**Development Consent Order for M25 Junction 28 Improvements.
On behalf of our clients Mr and Mrs Jones, Grove Farm, Brook Street, Brentwood, CM14 5NG**

We are writing regarding the procedural deadline B for our suggested locations/sites for the panel to include as part of their unaccompanied site inspections for Grove Farm.

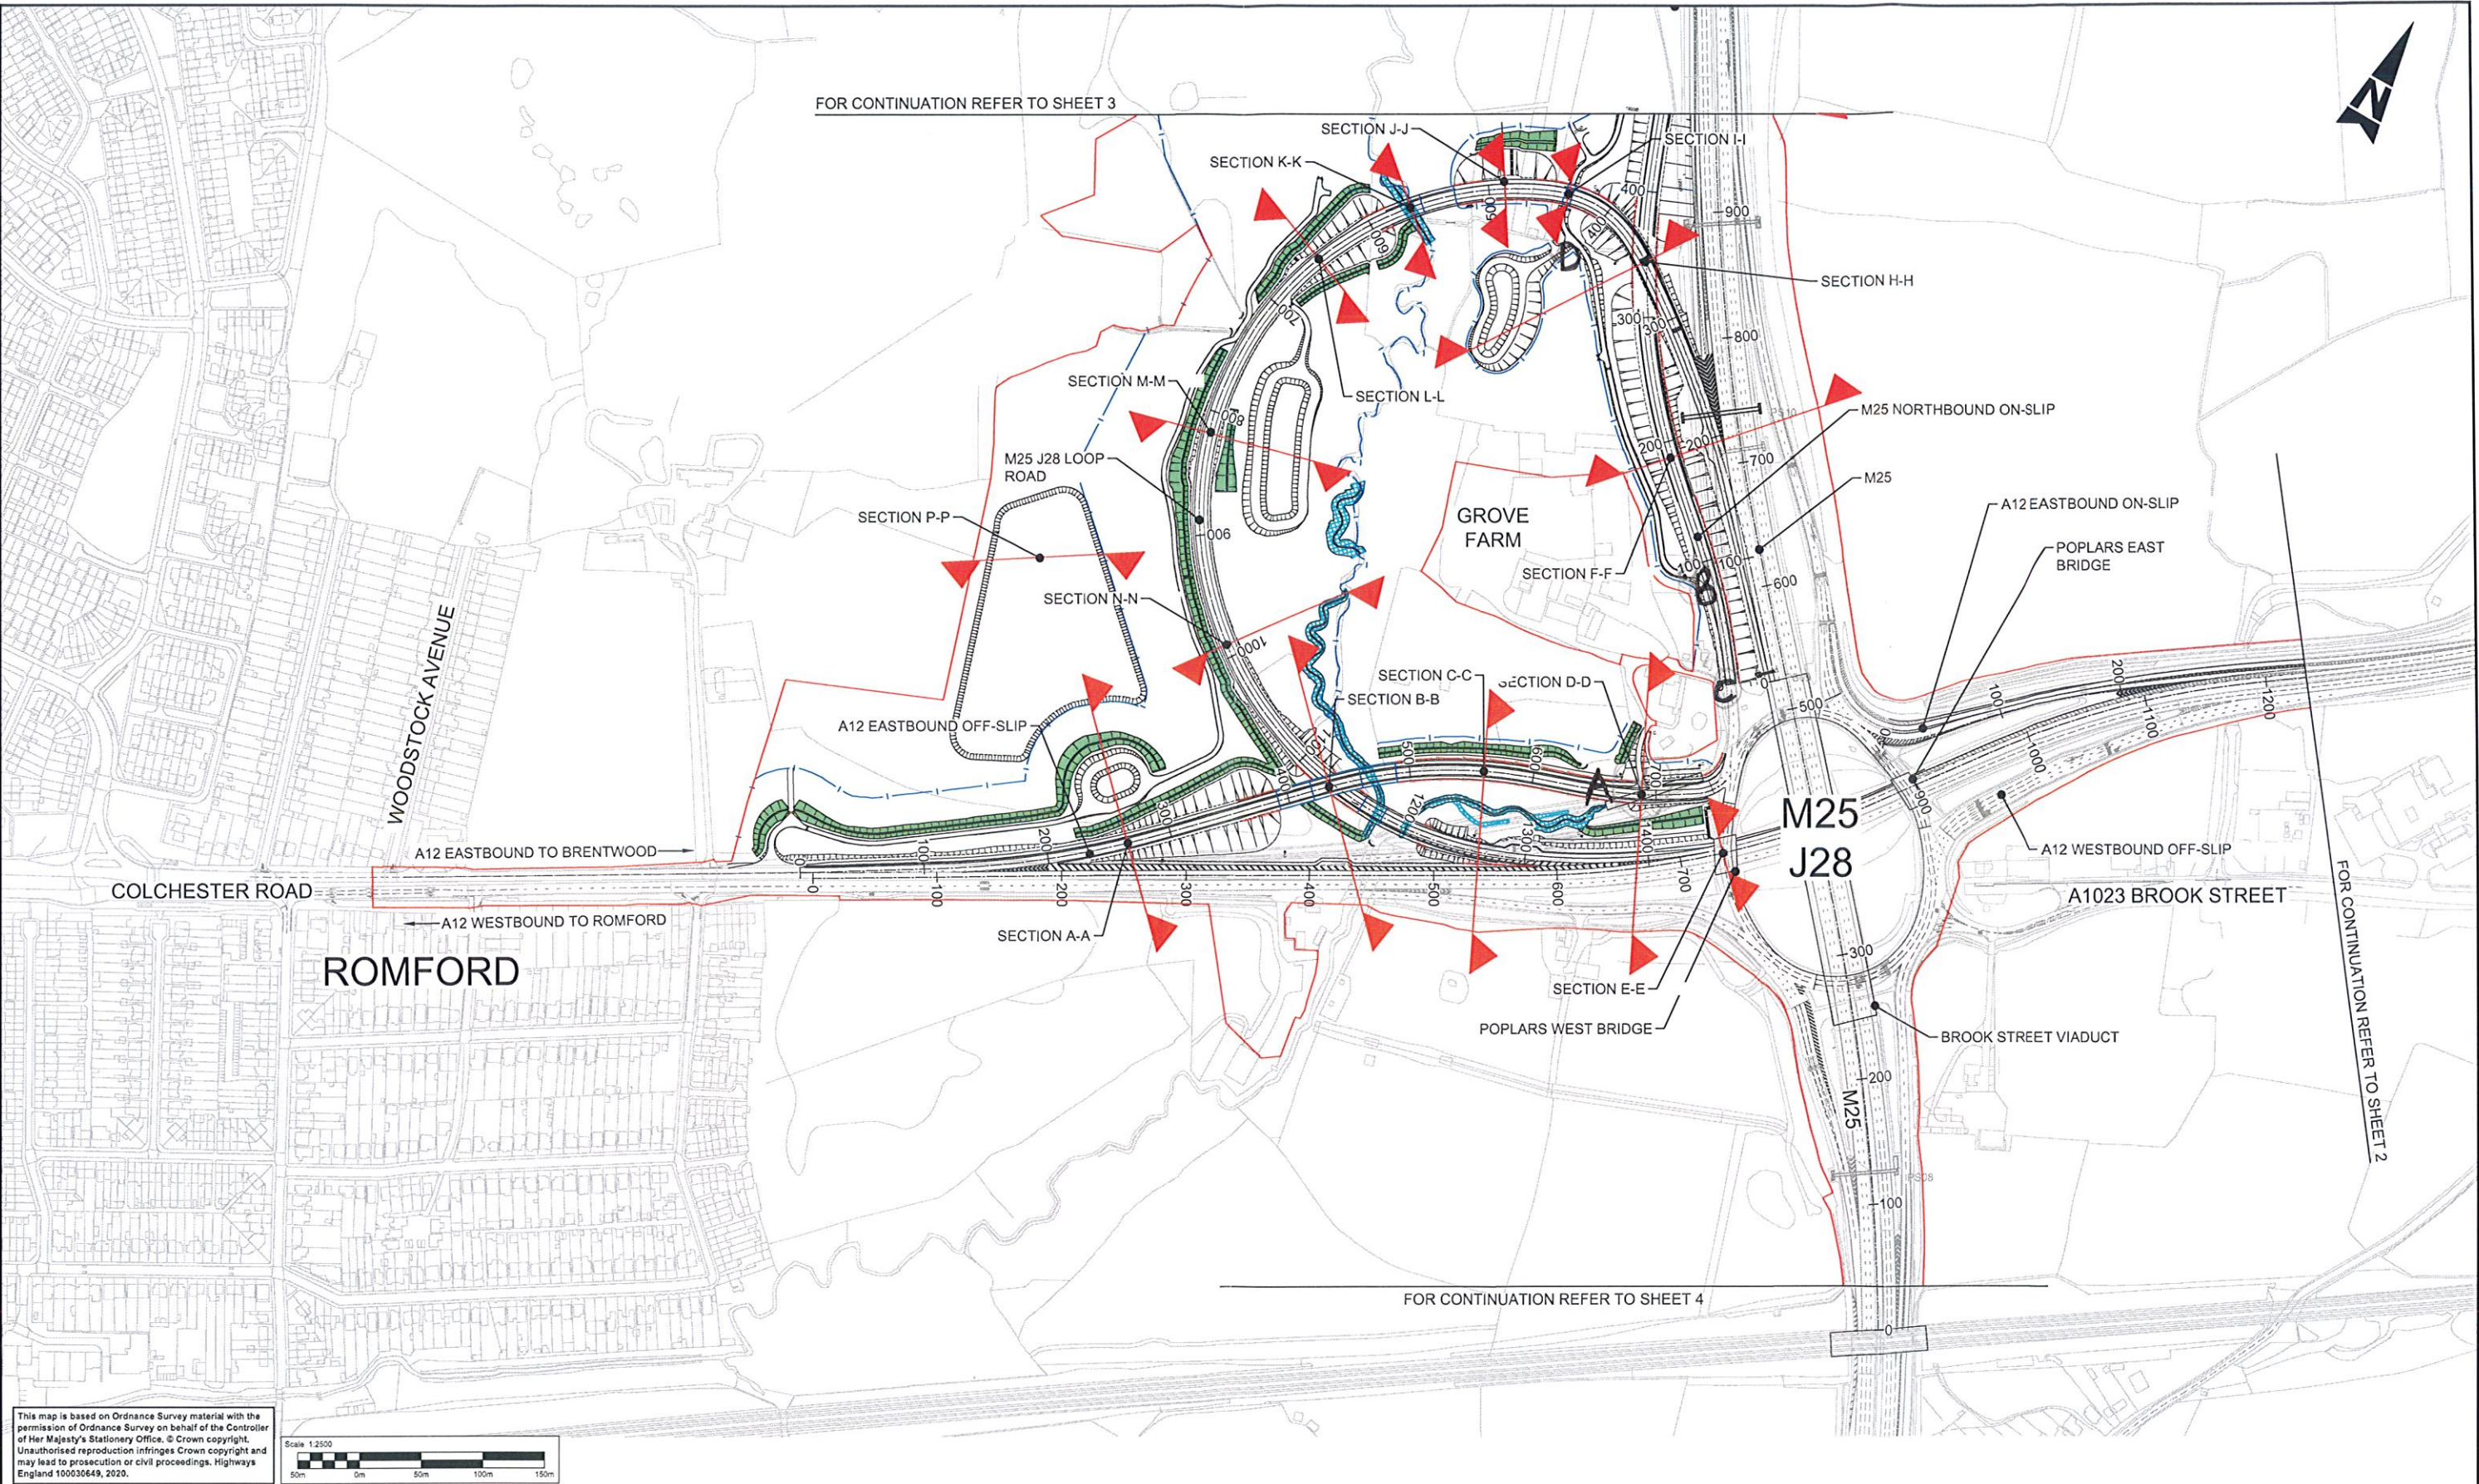
Point A – The existing access into Grove Farm.

It is noted that the new A12 east bound slip road would be located approximately 20m closer to the residential dwelling and at a significantly greater elevation making it level to the bedroom windows. At present it is appreciated there is no detailed noise and vibration mitigation measured guidance available therefore we are unable to understand the impact on the clients living conditions. We ask that you stand in the area to fully appreciate the impact on the clients lives.

Point B – The proposed access into the maintenance route

We are requesting that the Examining Authority walks the route between these two points and considers that it is feasible and preferable for these to be combined in to one access near to the substation serving both the site and the maintenance requirements.

Point C – The existing exit

It proposed that the works will ingress further on to Grove Farm to accommodate the existing access that the property uses to exit the site. This exit will be 20meters shorter than previous, reducing the space for vehicles to wait when existing the site. It is believed that it would be feasible and preferable to move the exit westwards down the slip road away from the house.

Point D – The proposed balancing pond

This is located at the end of the proposed maintenance track. It is requested that this site is inspected to appreciate the need for it to be located at the furthest point north of the property to keep it away from the other activities on site.
